Project No. 24-09  
CJUSD Central Freezer Facility

**Center Joint Unified School District  
CJUSD Central Freezer Facility @ M&O Yard  
Project No. 24-09  
8408 Watt Avenue, Antelope, CA 95843**

## ADDENDUM NO. 1 - 4/29/2024

T0

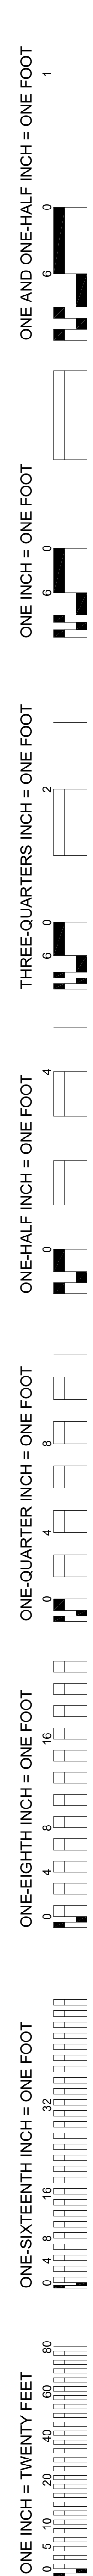
- Revise SHEET INDEX to add missing reference to sheet A5 - DETAILS.
- Revise SHEET INDEX to add new RMI/Airdyne reference drawing.
- Revise PROJECT TEAM to add Owner's Representative, Capital Program Management.

## A3

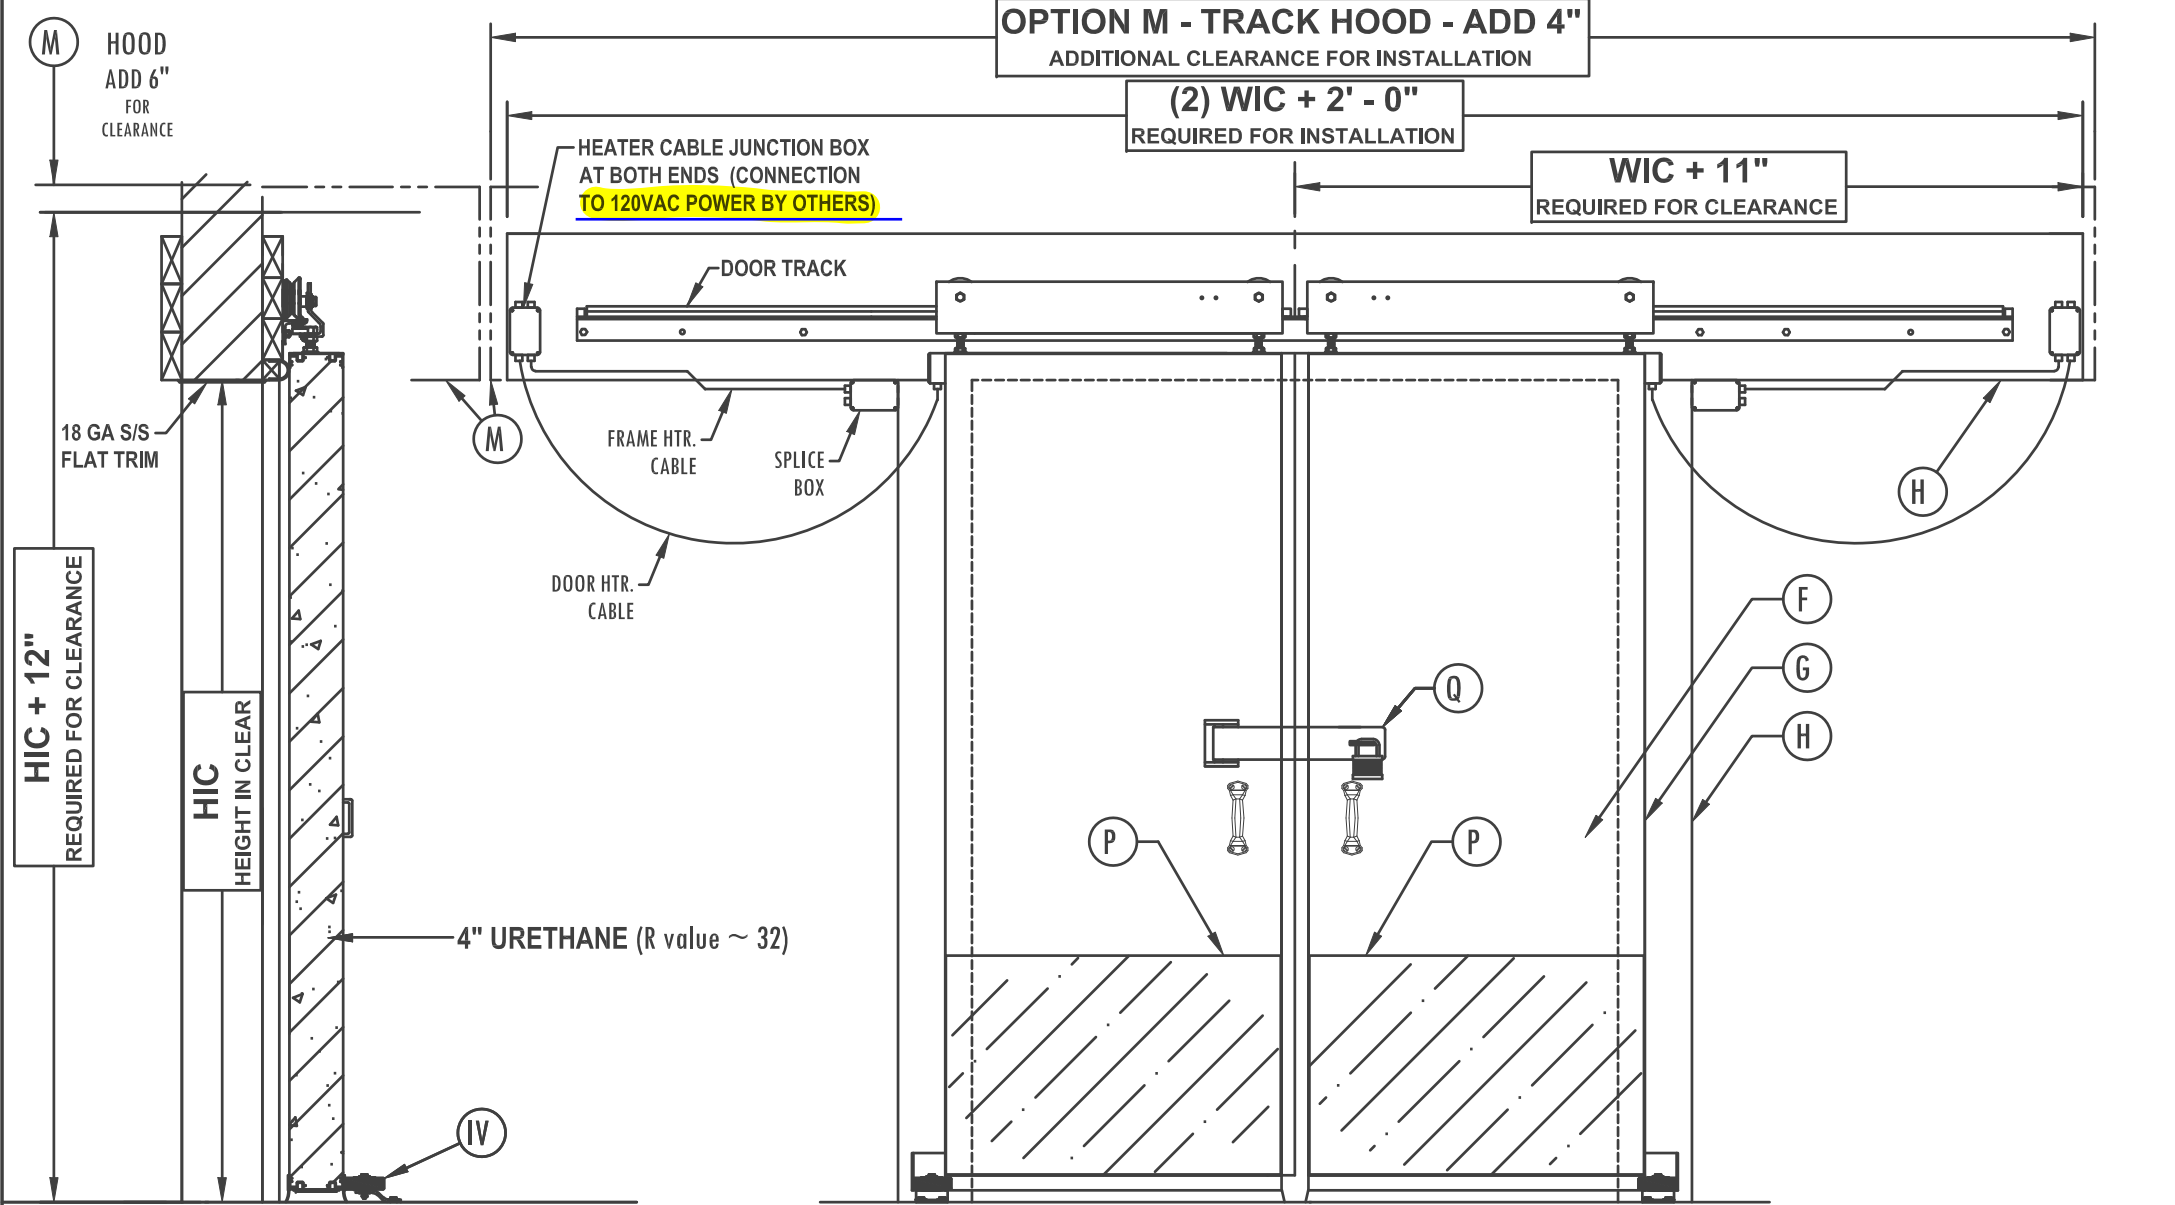
- Add sheet in its entirety. Sheet was missing from initial bid package - See attached.

**SHEET X1**

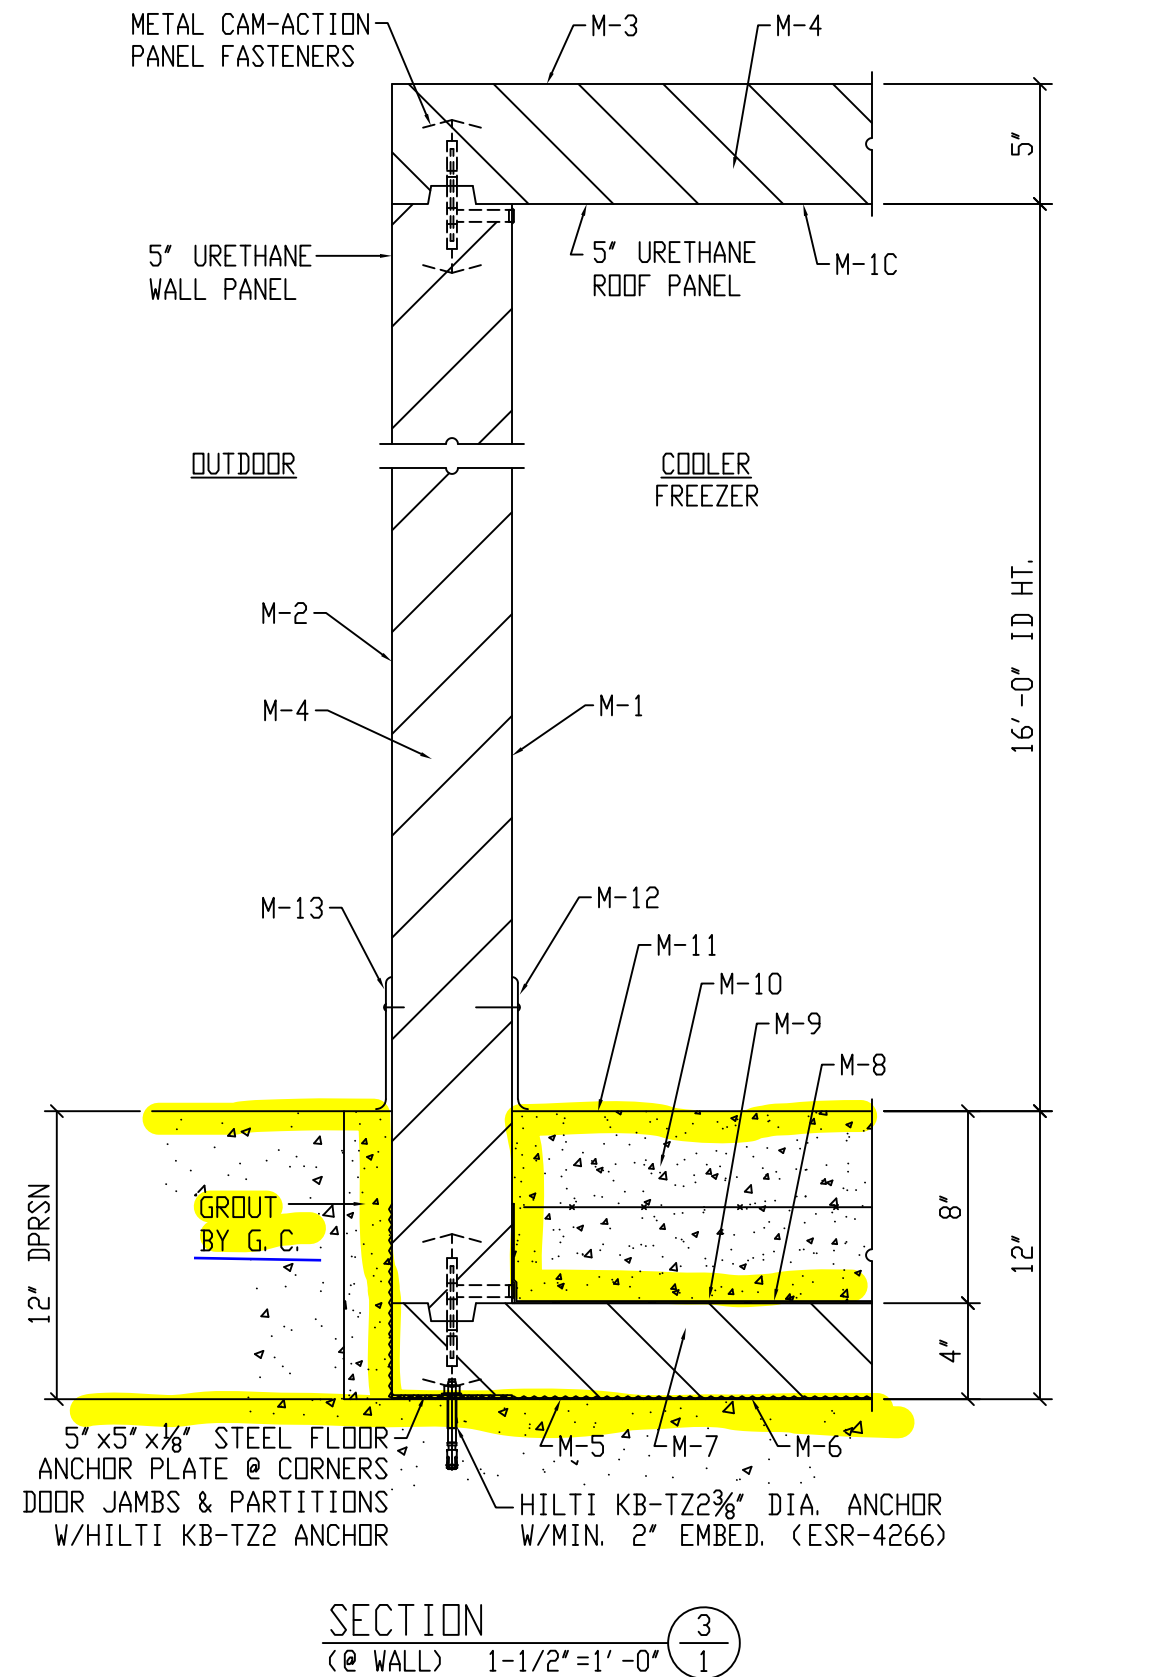
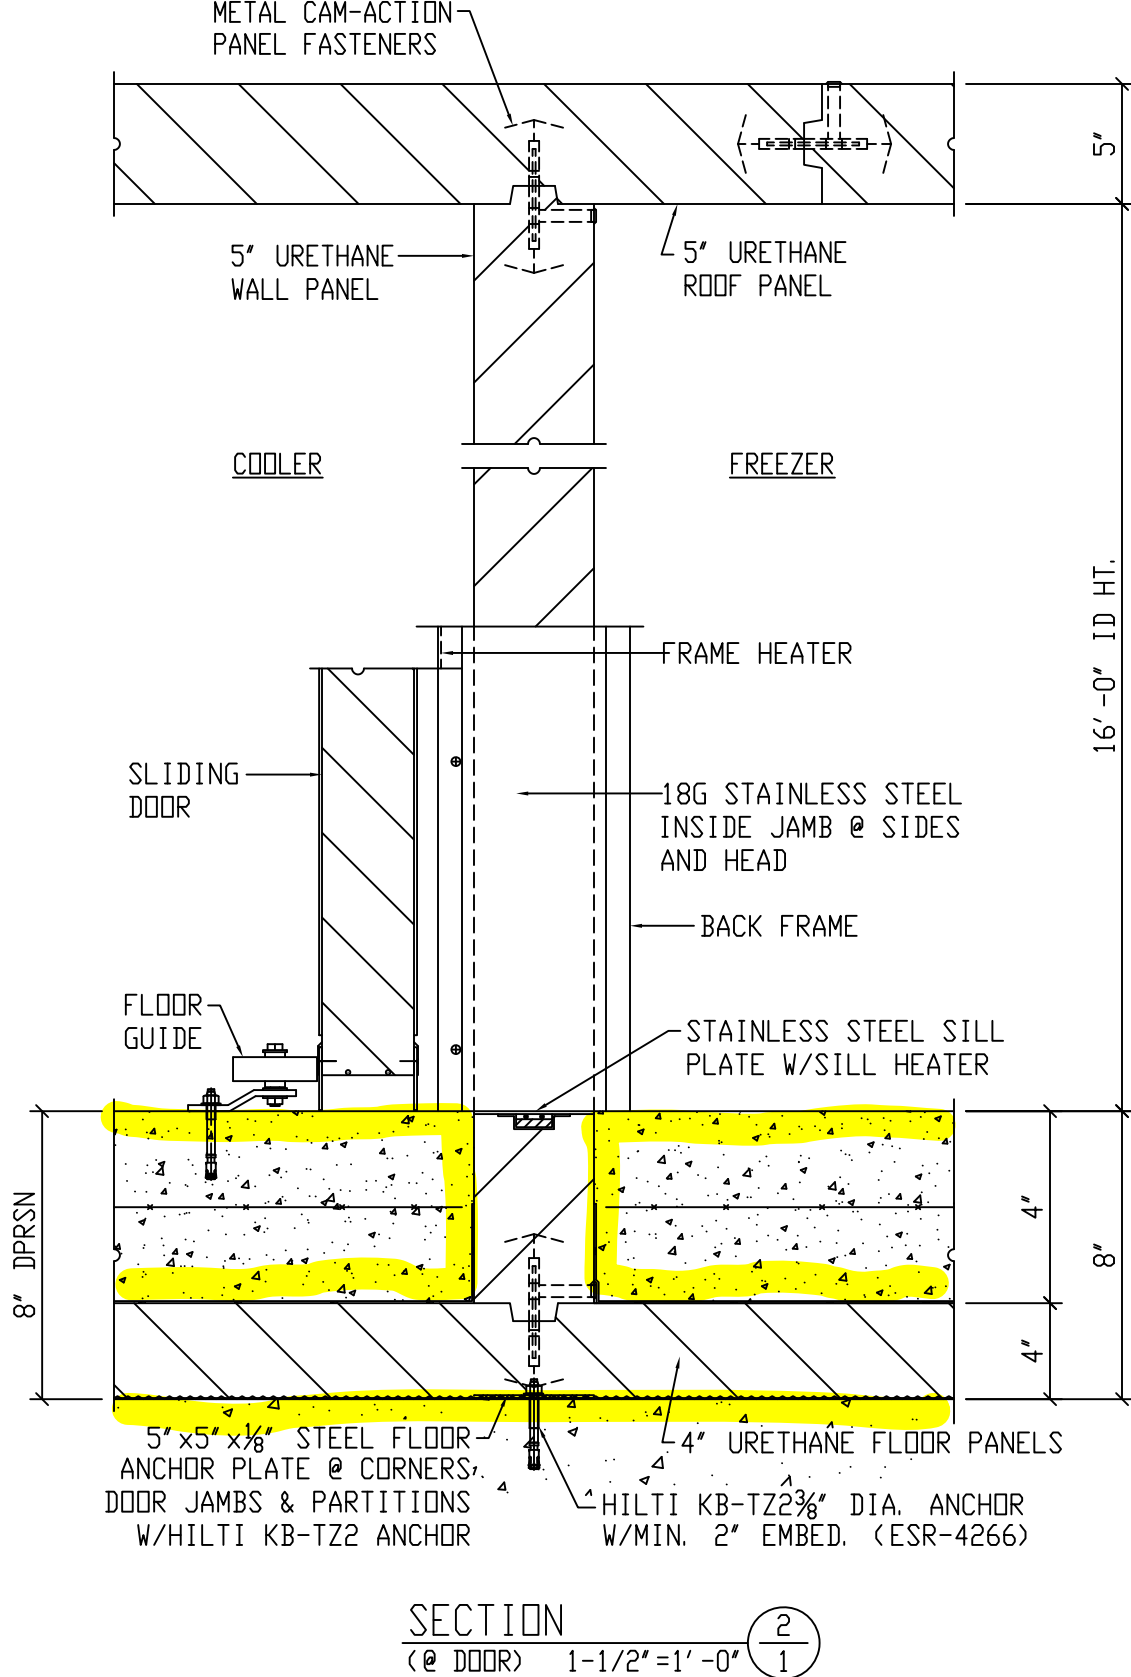
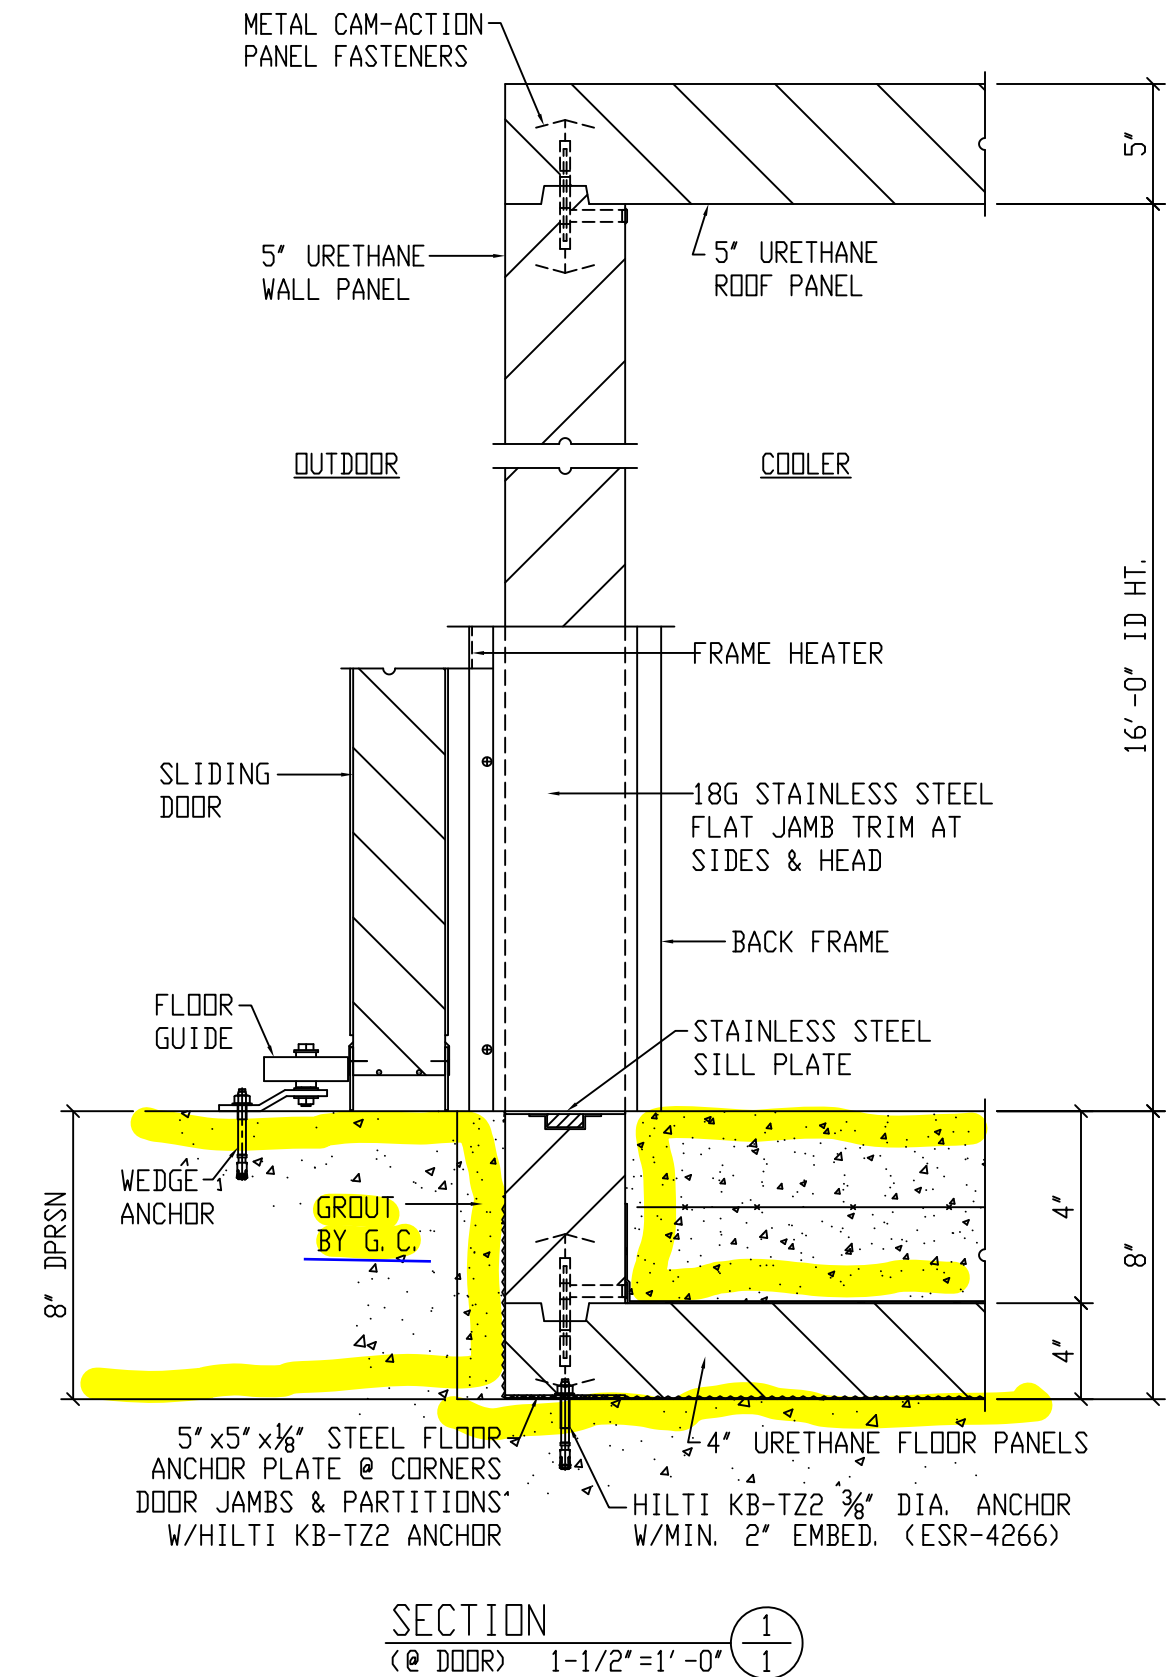
- Replace existing sheet in its entirety with new sheet - See attached.
- Note - While this sheet is primarily for reference for RMI/Airdyne provided and installed equipment, some site development work is identified on this sheet.
